City of Ramsey
Agenda
Regular Planning Commission
Thursday, June 1, 2017
7:00 pm
Council Chambers, 7550 Sunwood Drive NW

PUBLIC HEARING: Consider Request for Conditional Use Permit and Site Plan for Danner's Cabinet Shop, Inc. on the Property Located at 16735 Quicksilver St NW (Project No. 16-37): Case of Danner's Cabinet Shop, Inc.

DATE	MAY 26, 2017	**PROJECT ADDRESS**	16735 QUICKSILVER ST NW
PROJECT. TITLE	DANNER'S CABINET SHOP, INC.: CUP AND SITE PLAN		
ESCROW #	115687		
DEPARTMENT:	Community Development: Planning Division		
TECHNICAL REVIEWER:	Name: Chris Anderson Phone: 763-433-9817 Email: canderson@cityoframsey.com

Conditional Use Permit and Site Plan Review

1 Site Plan
1" = 20'-0"

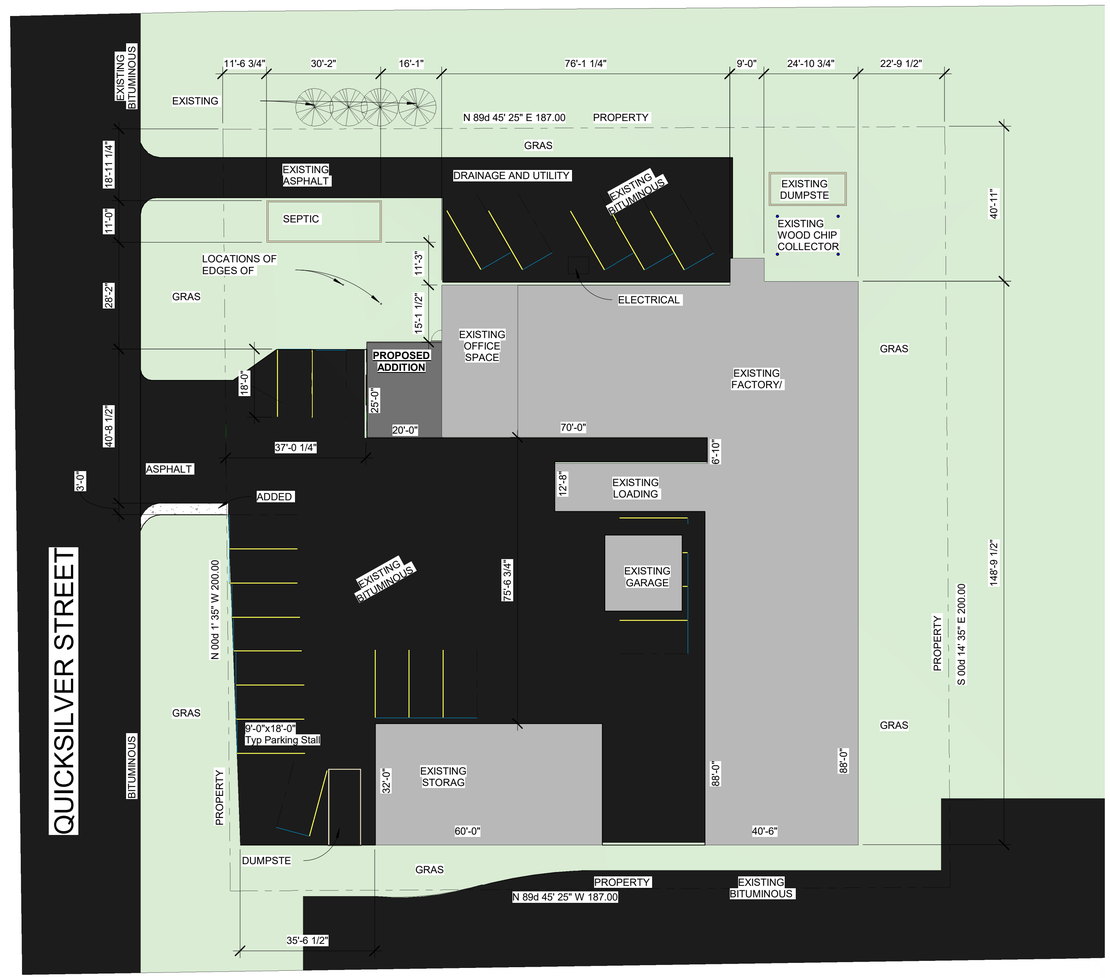
Sheet A000:

1. Add a calculations table to specify total existing square footage of building coverage, proposed square footage of new building, and total percentage of building coverage on the site.

2. Add background info on existing uses in building. More specifically, identify how much square footage of the building is for manufacturing/storage versus square footage for office type uses. This info is necessary to determine whether there is sufficient parking available on site per City Code.

3. General clean up is needed on the labels (misspellings), the line work and data is not legible with the black background. Change the background color and/or fill type.

4. Plan sheet has a label stating "Location of Edges of". What is that referring to? Clarify on plan sheet.
5. Two (2) additional parking spaces are required based on the proposed 500 square feet of new office space. This can be accomplished via 'proof of parking' but must be shown on the Site Plan.

Sheet Title: ELEVATIONS

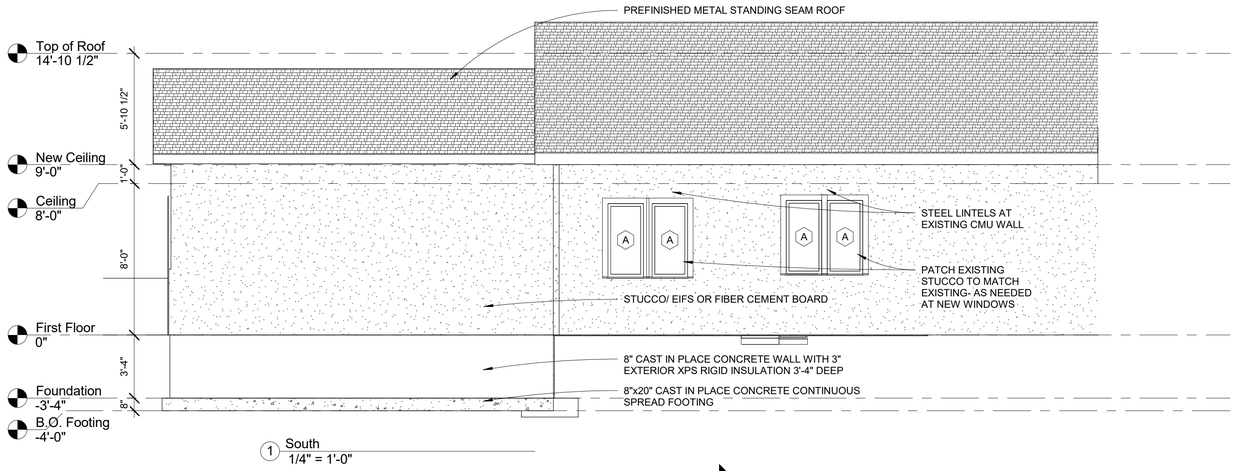
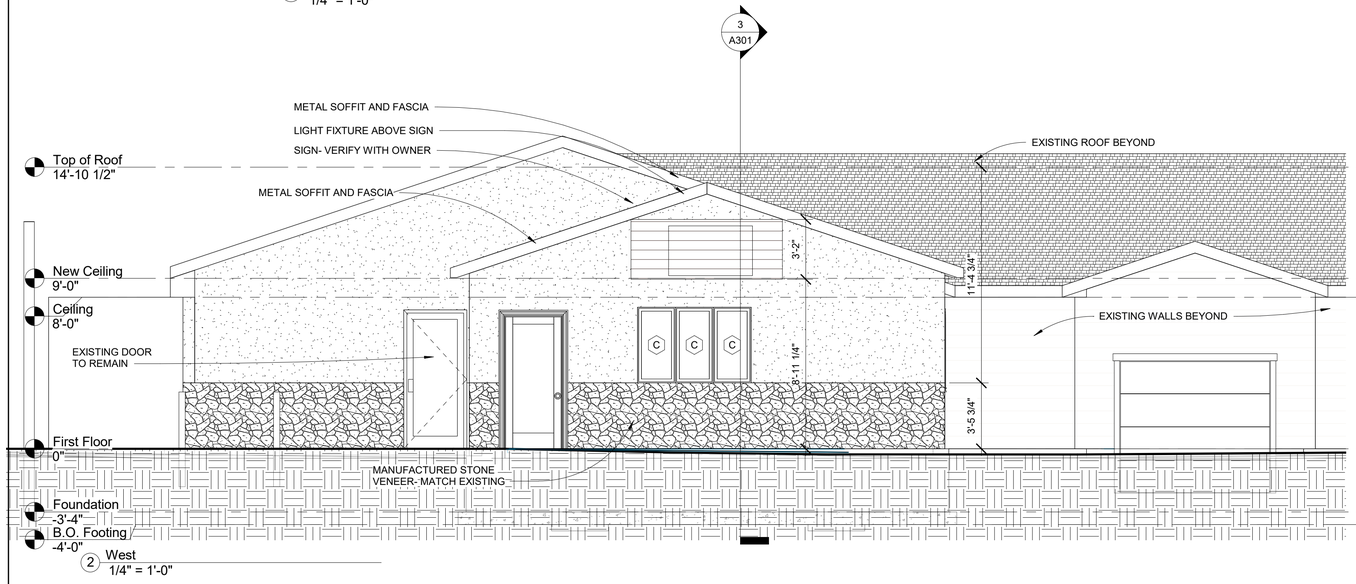
Sheet A300:

1. The exterior finish of the existing front façade is all stone veneer. Update the plan set to correctly reflect this (currently shows a combination of stone veneer and EFIS). Alternatively, add note to plan set that states that exterior finish will be updated as shown on the west elevation on this plan sheet.

2. Septic location must be protected throughout construction. Add that note (and barrier) to plan set.
3. Septic system must be evaluated to ensure sufficient capacity to accommodate the proposed building expansion.
4. The building expansion may require fire suppression. Coordinate with the Building Official for this determination.

EXISTING CONDITIONS AND REMOVALS
CITY OF RAMSEY, MINNESOTA

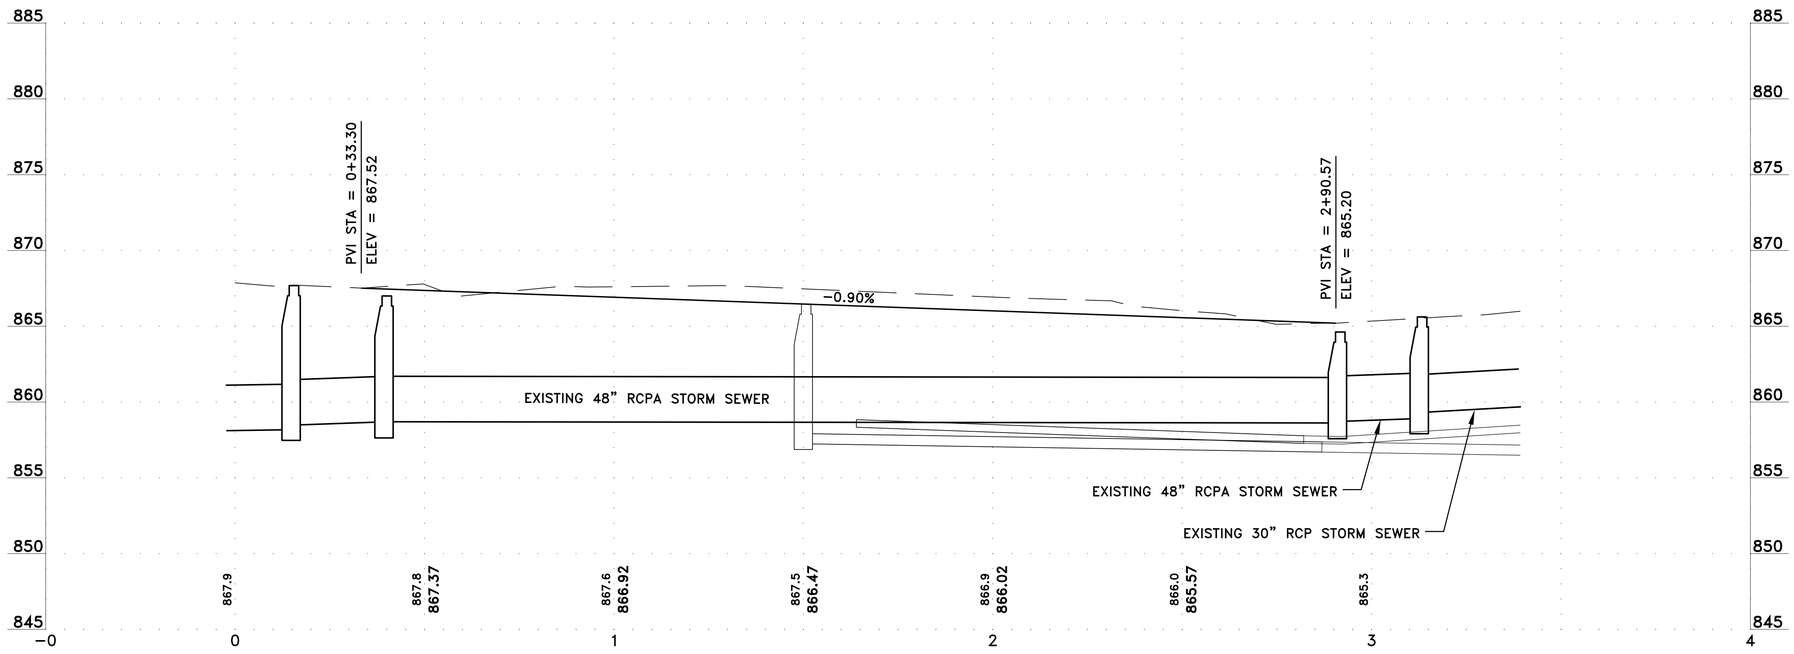
Sheet 11

1. Add note to storm sewer removal "Remove pipe to structure and bulkhead."
2. Reference Detail STR25 at the pavement removal area.
3. Callout quantity of bituminous pavement to remove and quantity of concrete pavement to remove.
